CALIFORNIA COASTAL COMMISSION

MEMORANDUM

Subject: **Addendum to Commission Meeting for Friday, November 19, 2010**
North Coast District Item F 8c, CDP No. 1-10-010 (Maier)

Staff is proposing to make minor changes to the November 4, 2010 staff recommendation on Coastal Development Permit Application No. 1-10-010. The project description includes the proposed development of a new 416-square-foot, maximum 15.5-foot-high attached one-car garage and associated compacted crushed gravel driveway. Special Condition No. 1 of the staff recommendation, which would require submittal of revised plans prior to permit issuance for the Executive Director's review and approval that demonstrate the following: (a) any new development proposed seaward of the 160-foot geologic setback line from the bluff edge shall be deleted, including the proposed compacted crushed gravel driveway and proposed stamped concrete walk, and (b) the proposed one-car garage shall be redesigned so that access to its primary entrance is landward of the 160-foot geologic setback line from the bluff edge. The applicants' consulting engineer has informed staff that the redesign of the one-car garage and driveway required by

**PROPOSED SITE PLAN &
ELEVATIONS (1 of 5)**

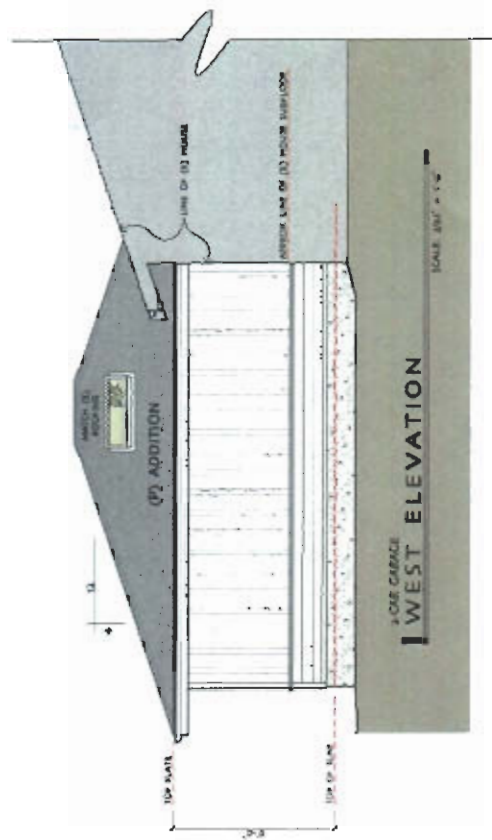
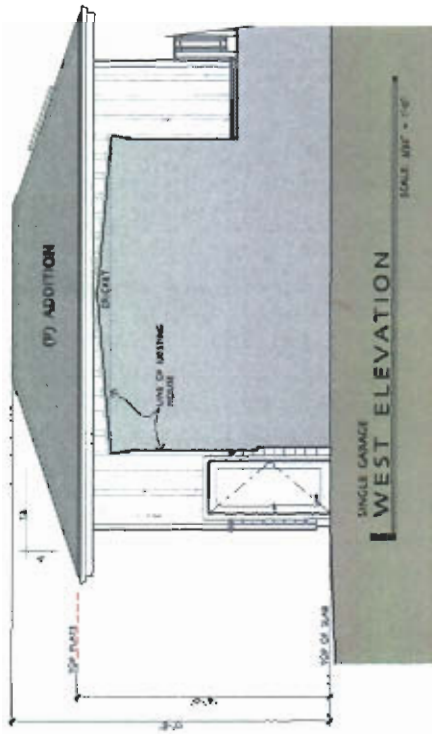
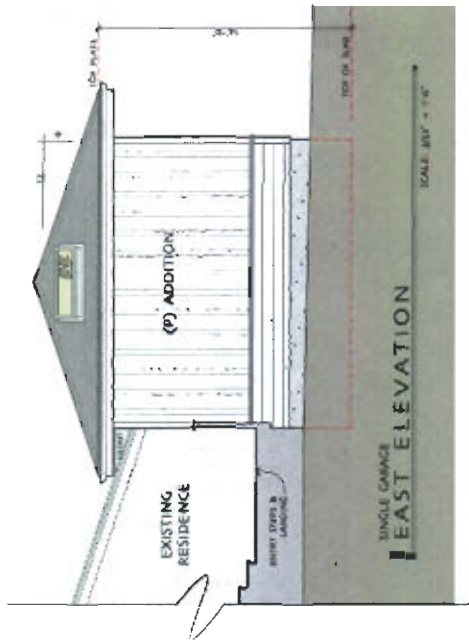
- *Add language to Special Condition No. 1 on page 5 as follows:*

1. Any new development proposed seaward of the 160-foot geologic setback line from the bluff edge shall be deleted, including the proposed compacted crushed gravel driveway and proposed stamped concrete walk;
2. The proposed one-car garage shall **either** be **deleted or** redesigned so that access to its primary entrance is landward of the 160-foot geologic setback line from the bluff edge; and
3. The foundations for the proposed new garages shall be designed to facilitate moving the structures in the future if necessary.

- *Modify the text of the “Geologic Hazards” Finding No. IV-C on pages 12-13 as follows:*

Although the proposed new garage additions both are located landward of the geologic setback line identified in the Busch report and approved by the Commission’s geologist in 2003, the applicants are proposing some new development seaward of the recommended geologic setback line including (1) portions of the new compacted crushed gravel driveway associated with the proposed new one-car garage, and (2) a new stamped concrete walk extending from the proposed new one-car garage entrance to the existing lawn area west of the existing residence. The Commission finds that such approval of new development seaward of the recommended geologic setback would not be sufficient to protect such development from bluff retreat hazards over its expected economic life consistent with the requirements of Section 30253. Furthermore, the current design plan for the one-car garage, as proposed, shows the garage door facing and immediately adjacent to/abutted against the recommended geologic setback line. If the compacted crushed gravel driveway proposed to serve the garage were to become threatened by bluff retreat hazards in the future (due to its proposed location seaward of the geologic setback line), the one-car garage, as proposed, would be non-functional. Therefore, the Commission

attaches **Special Condition No. 1**. This condition requires submittal of revised plans prior to permit issuance for the Executive Director's review and approval that demonstrate the following: (a) any new development proposed seaward of the 160-foot geologic setback line from the bluff edge shall be deleted, including the proposed compacted crushed gravel driveway and proposed stamped concrete walk, and (b) the proposed one-car garage shall either be deleted or redesigned so that access to its primary entrance is landward of the 160-foot geologic setback line from the bluff edge. Reorienting the garage to face landward of the bluff or up coast and making associated driveway changes would be feasible, as the driveway entrance to the site is located landward of the home and the areas between the garage and the street and northern property line contain no known environmentally sensitive habitats or other significant constraints to development. Special Condition No. 1 also requires that the foundations for the proposed new garages shall be designed to facilitate moving the structures in the future if necessary. Coastal Development Permit No. 1-03-024 similarly required that the foundations of the relocated home be designed to facilitate moving the structures in the future if necessary.
